145.2.5.6 Functions: Add pri and sec versions of do_class_probe.

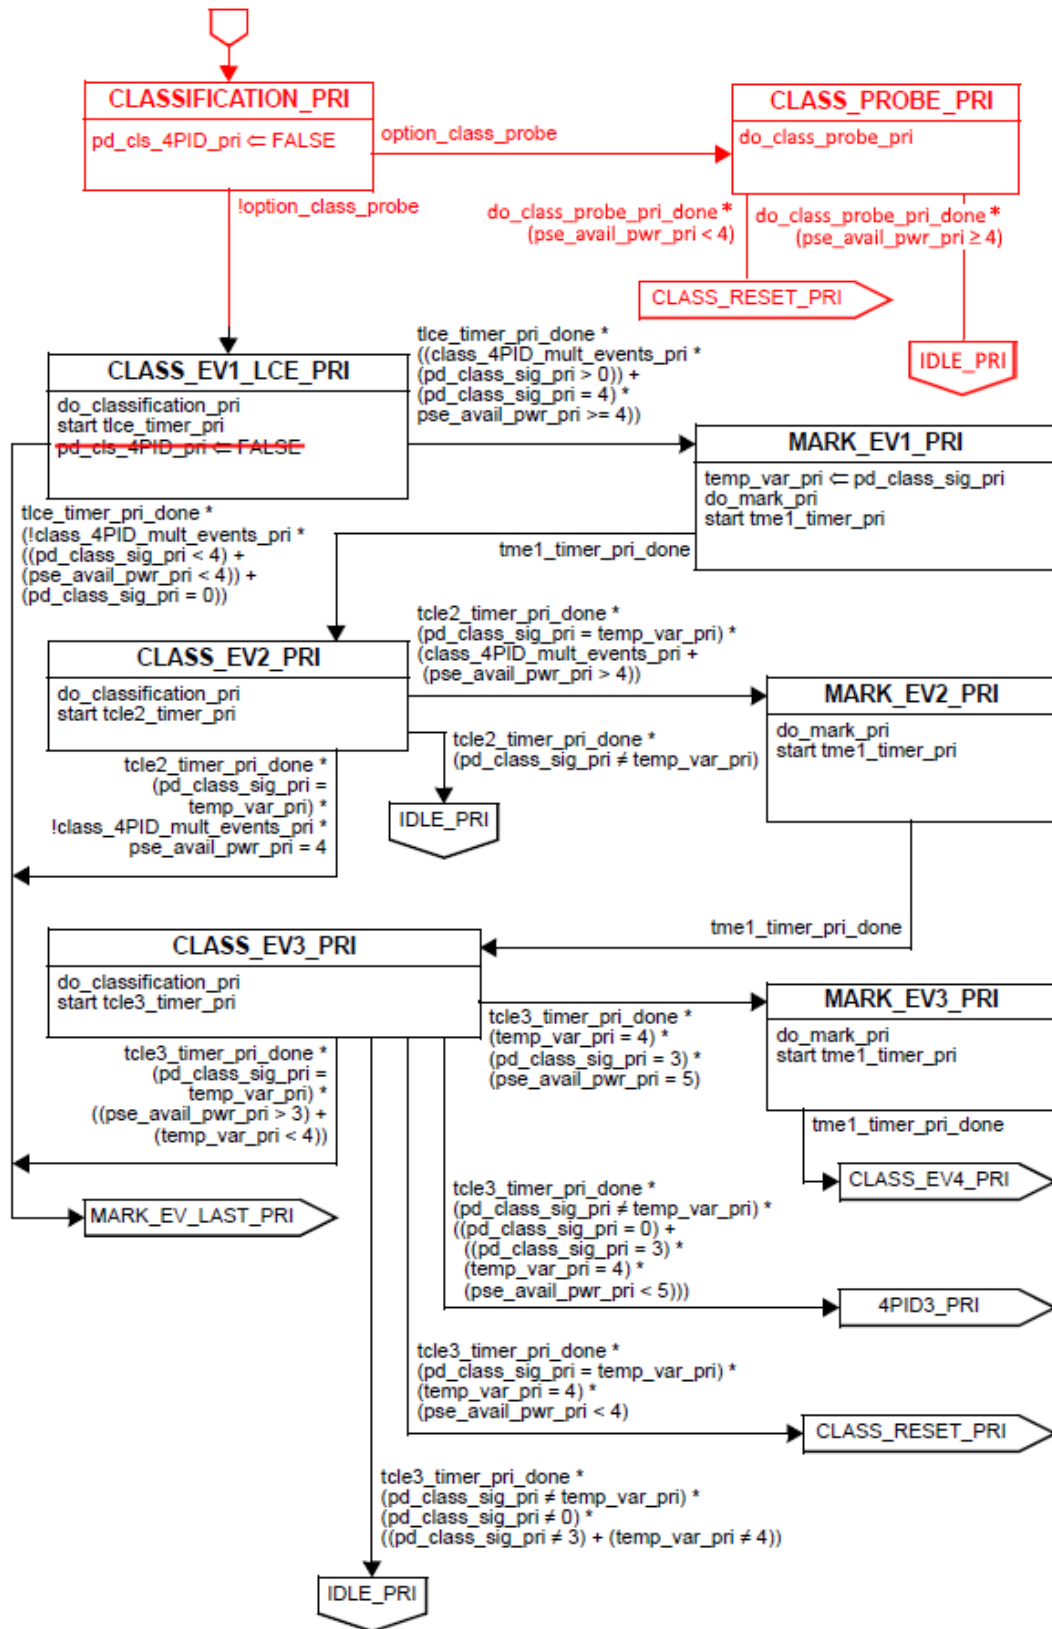
Modify Figure 145-15 to connect DETECT_EVAL_PRI to CLASSIFICATION_PRI

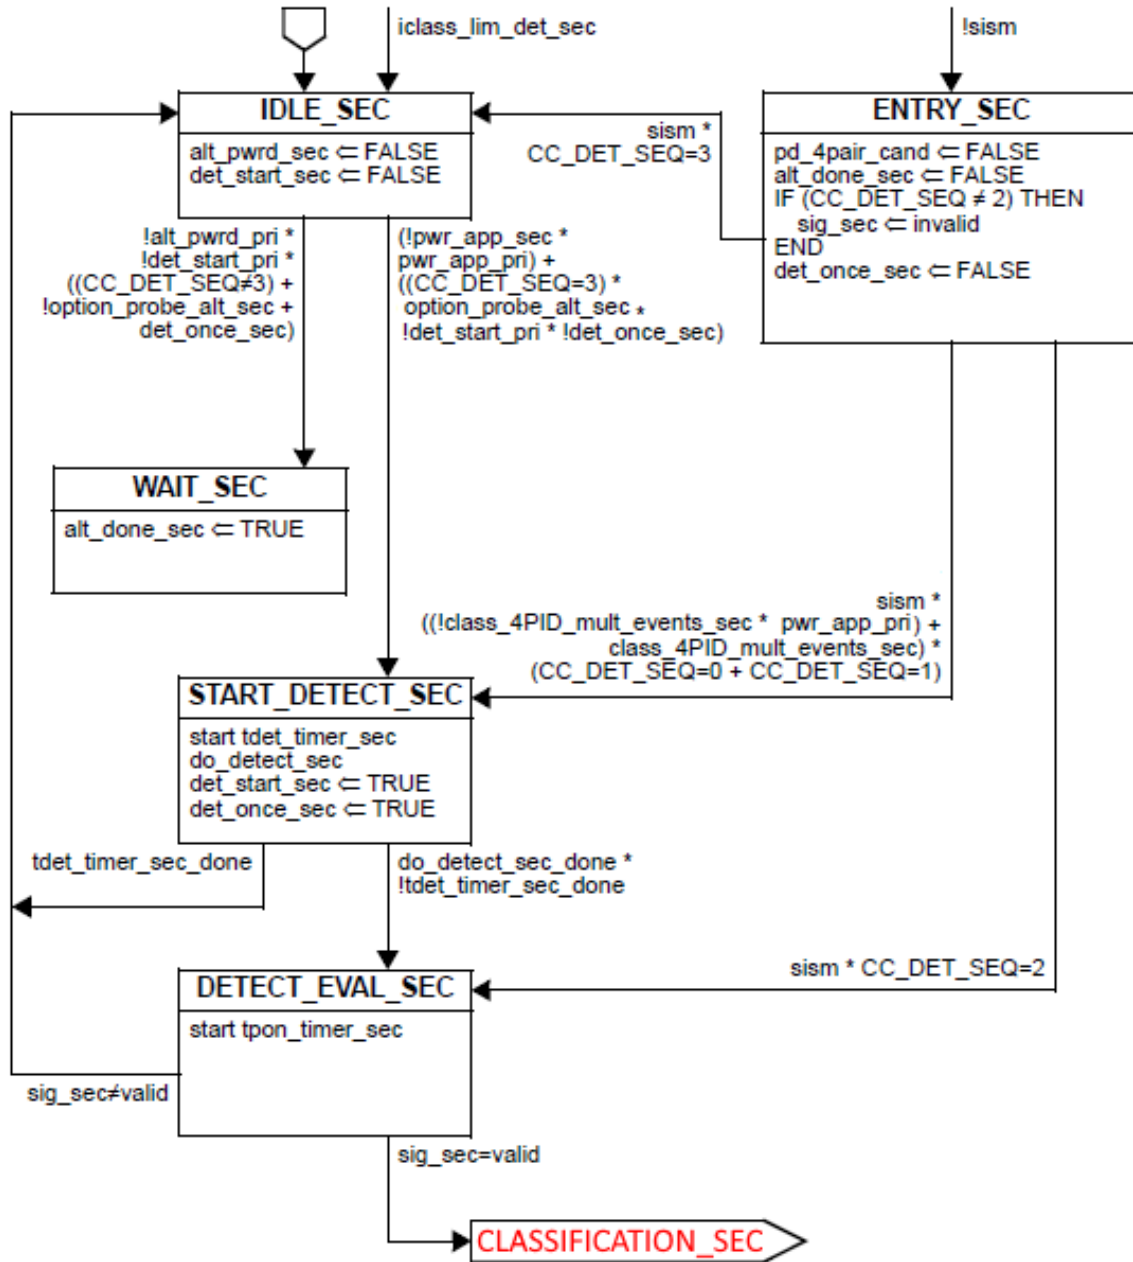
Modify Figure 145-15 to allow CLASS_PROBE_PRI
